## COMMISSION OF ARCHITECTURAL REVIEW STAFF REPORT March 24, 2015, Meeting

**6. CAR No. 15-038** (L. Chavis)

873 M 22nd Street Union Hill Old & Historic District

**Project Description:**

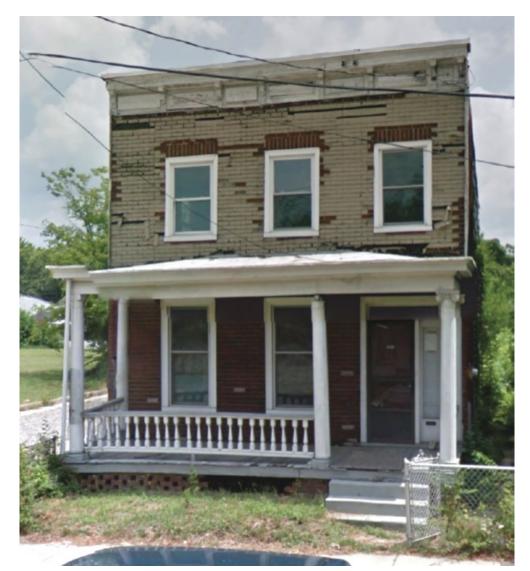
In preparation of this staff report, staff has learned that a historic turned balustrade was present at the time the District was established as it is shown in a picture of the property from 2011 and also noted in the Union Hill National Historic District Nomination application. As the Guidelines recommend that historic material and details of porches should be retained and repaired or replace in-kind (pg. 67, #8), the original balustrade should have been repaired or replaced in-kind, not removed. As a result of this additional information about this property, this application warrants additional discussion. The Commission may wish to consider whether it would be appropriate to require the applicant to include turned balusters in the proposed design as the guidelines recommend that "when replacing a railing on a historic building which has lost its railing, the first step is to look for documentary evidence which records the appearance of that railing" (pg. 67). Staff recommends the replacement of removed railing with in-kind materials to include turned balusters.

- The removed railing on the front porch should be replaced with in-kind materials to include turned balusters. The Commission may wish to decide whether Richmond rail for the replacement of a missing railing is appropriate in this case as that was the original recommendation of staff during their initial site visit.
- The rear porch and stairs should be designed as was approved by in the Certificate of Appropriateness # 14-023. Staff recommends that the applicant use a standard Richmond rail for a design that is compatible with the district, or that the applicant place the proposed pickets on the inside of the handrail for a more finished appearance.
- The structure should be painted as proposed.
